TRANS/WP.29/999
2 April 2004

World Forum for Harmonization of Vehicle Regulations (WP.29)

DRAFT SUPPLEMENT 10 TO THE 03 SERIES OF AMENDMENTS
TO REGULATION No. 36

(Large capacity passenger vehicles)

"Figure 6b

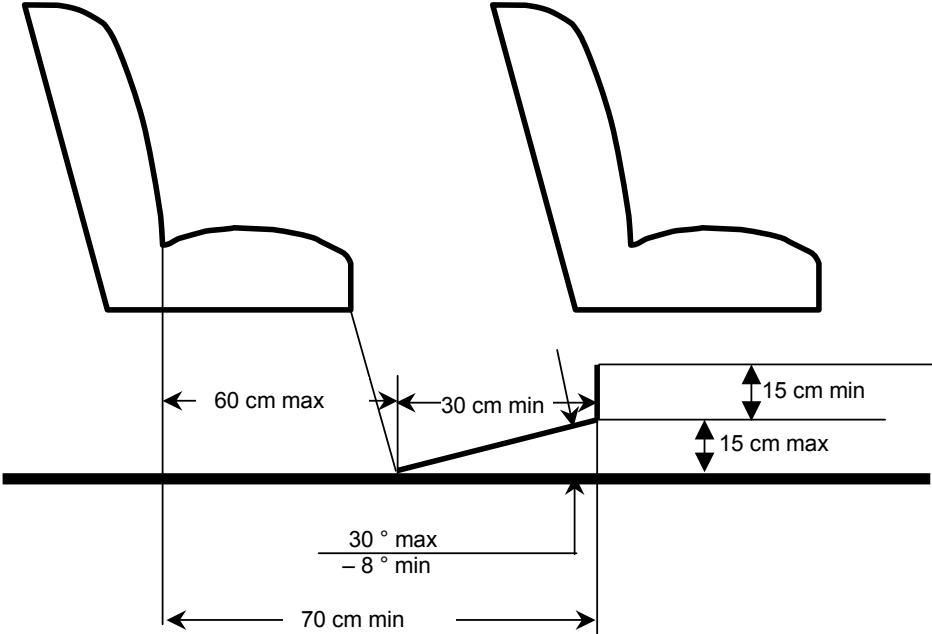
Insert a new paragraph 5.7.8.5.2., to read:

"5.7.8.5.2. For a seat behind a seat and/or a seat facing the gangway, a minimum clear foot space of at least 300 mm depth and a width according to paragraph 5.7.8.1.1., shall be provided as shown in annex 3, figure 6b. The local presence in this space of seat legs and of intrusions as provided by paragraph 5.7.8.6.2.3. shall be permitted provided that adequate space remains for the passengers' feet. This foot space may partly be situated in and/or above the gangway but shall not create any obstruction when measuring the minimum gangway-width in accordance with paragraph 5.7.5."

Insert a new figure 6b, to read:

SPACE FOR SEATED PASSENGERS BEHIND A SEAT AND/ OR A SEAT FACING THE
GANGWAY
(see paragraph 5.7.8.5.2)
